TfNSW Reference: SYD13/01267/13

PUBLIC EXHIBITION OF REVISED CARTER STREET PRECINCT MASTER PLAN

Attachment A: TfNSW Detailed Comments on Revised Carter Street Master Plan

Figure 23: Public Open Space Network

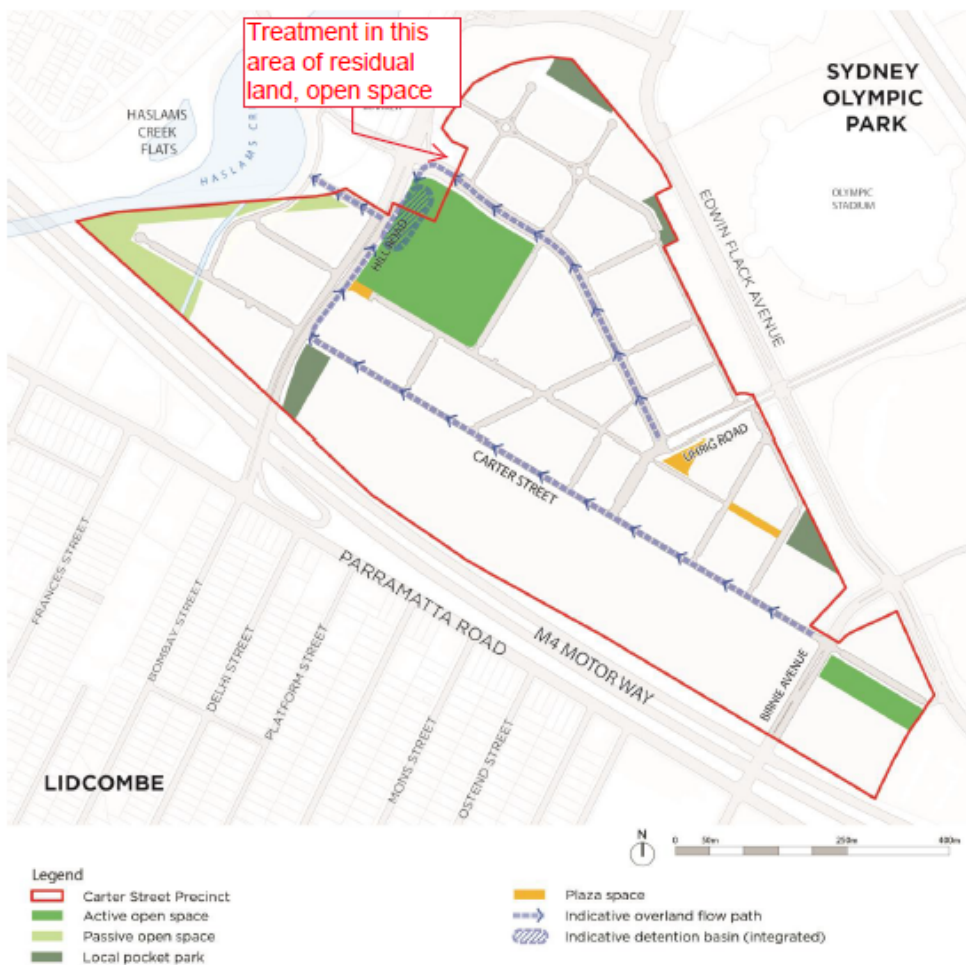
5. Figure 23 - the overland flow paths noted in the Public Open Space Network plan appear to be a new inclusion. The drainage strategy was dealt with in the median areas and verges of Green Spine in earlier versions of the Master Plan. The design of the stub (80 metres long) from John Ian Wing Parade to Green Spine doesn't cater for this direction of flow. The location of the detention basin may also affect the size of the available public open space.

6. Regarding treatment of residual land adjoining the Hill Road upgrade, we note an area of residual land (location indicated in **Attachment B**) could be shown as future open space/landscaping in the Public Open Space Network.
